PROPOSED STARBUCKS

PARCEL ID: 15-09-476-030
1360 WALTON BOULEVARD
CITY OF ROCHESTER HILLS
OAKLAND COUNTY, MICHIGAN

LANDSCAPING PLAN

C-10

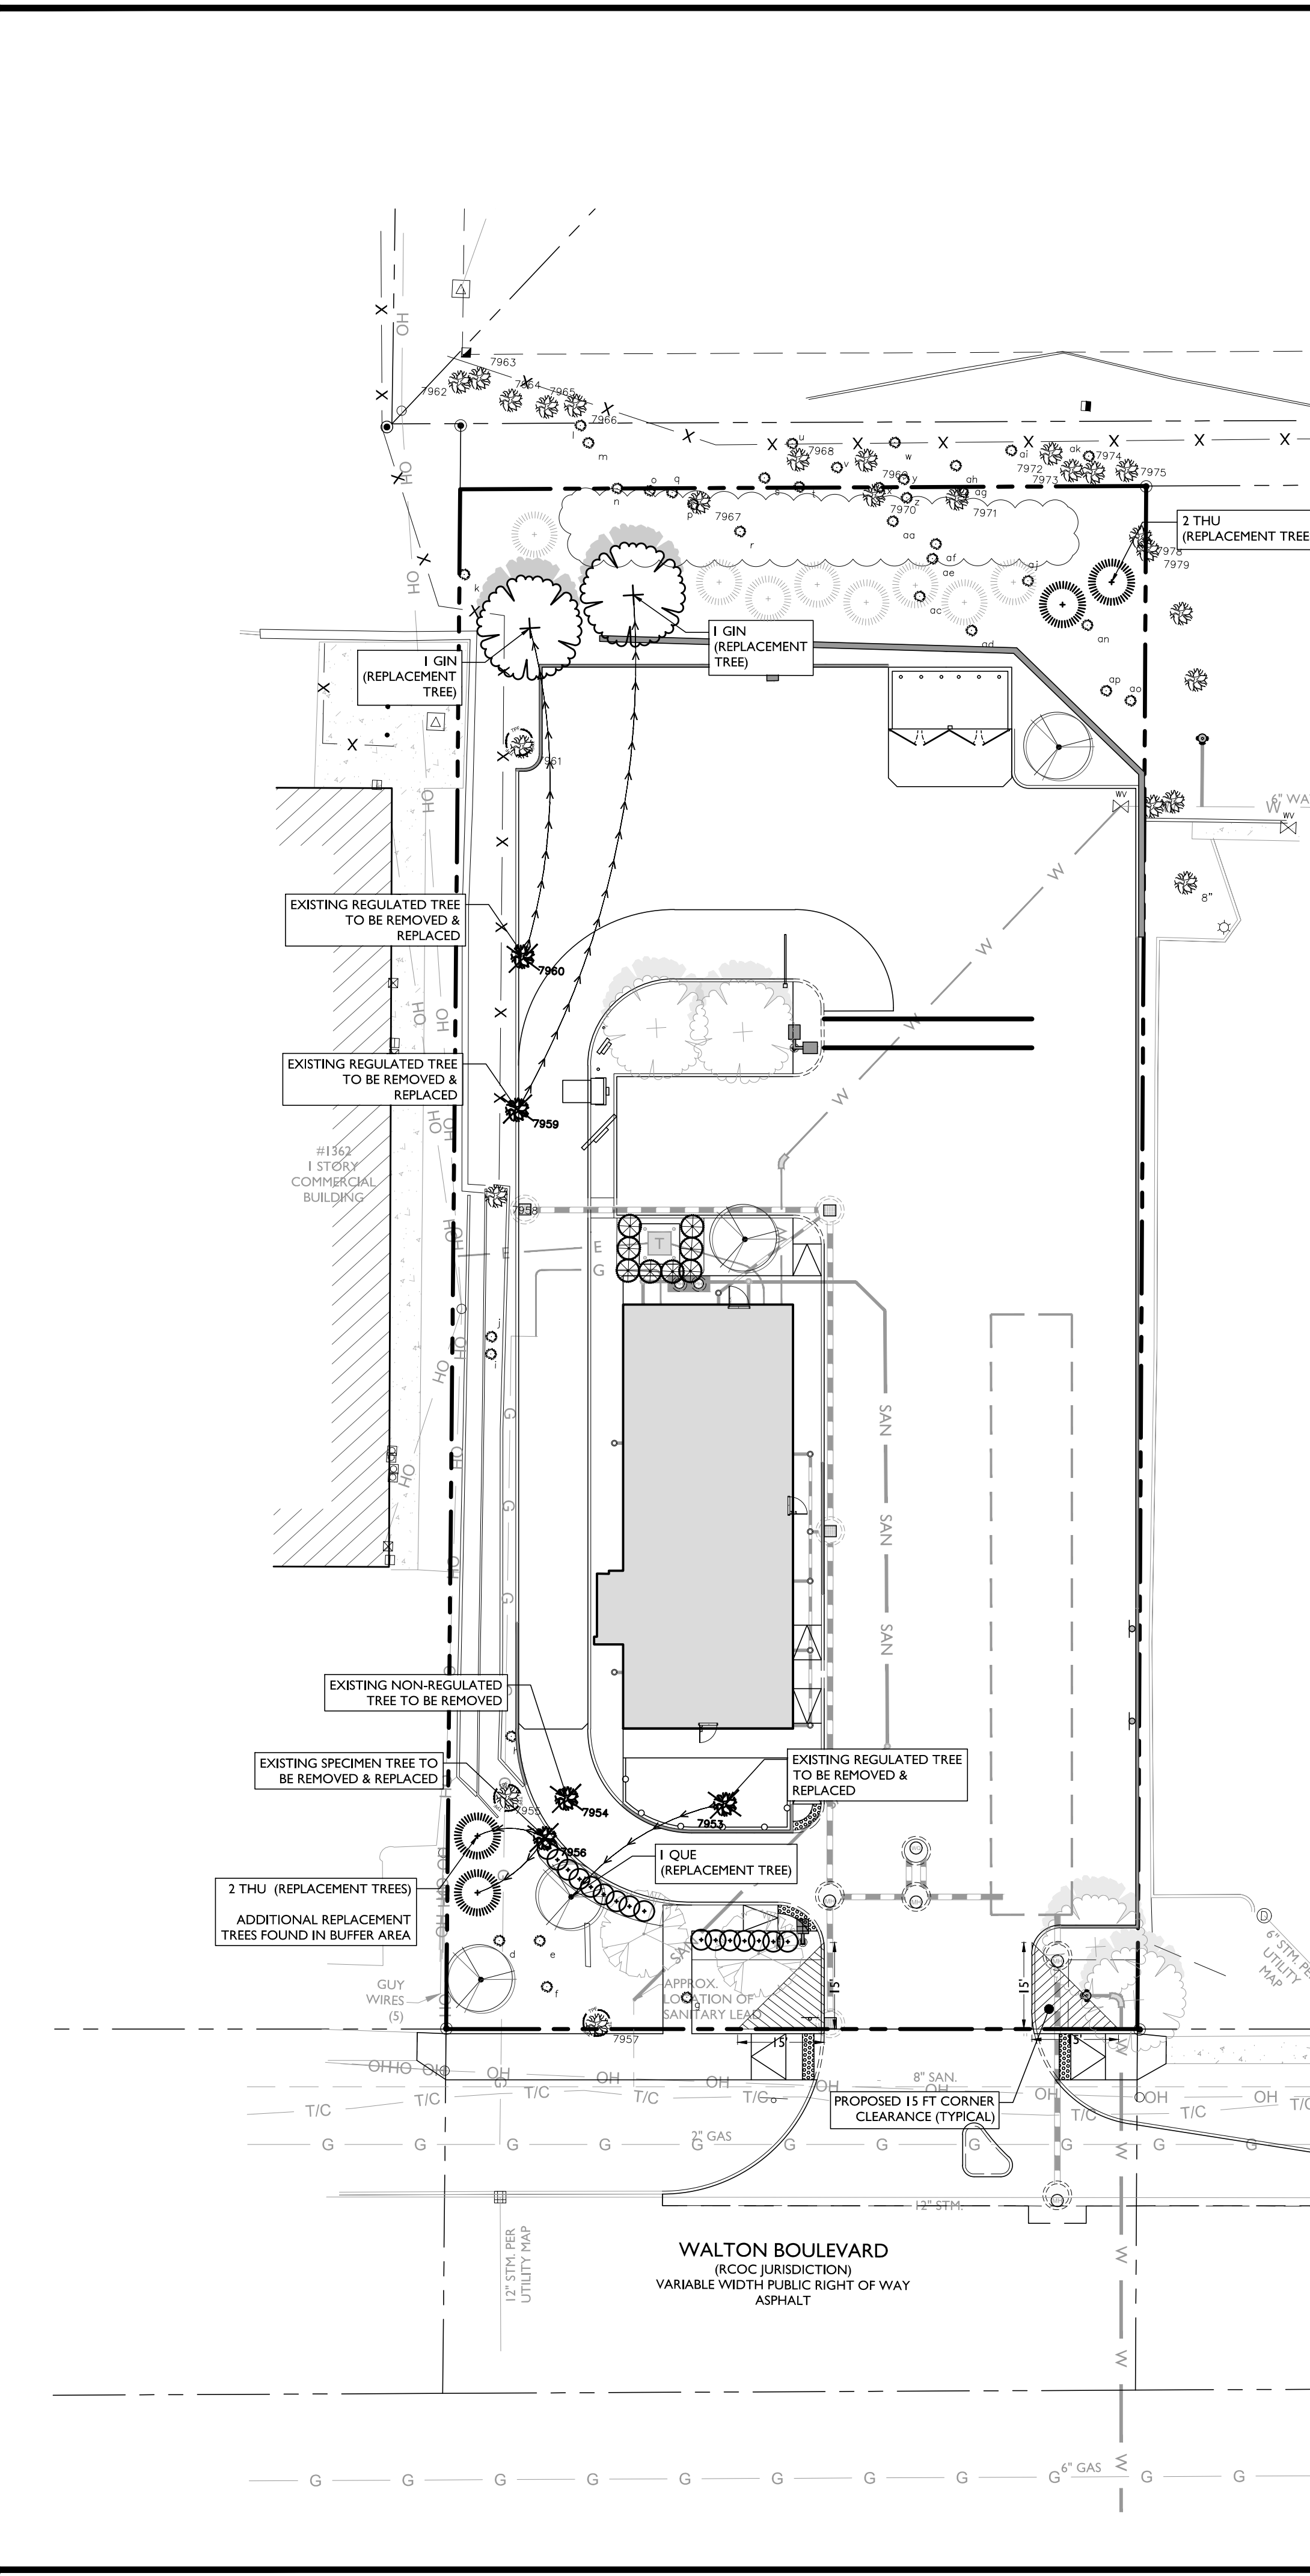
Include Road and Pathway Sight Distance Lines per the attached City Details.
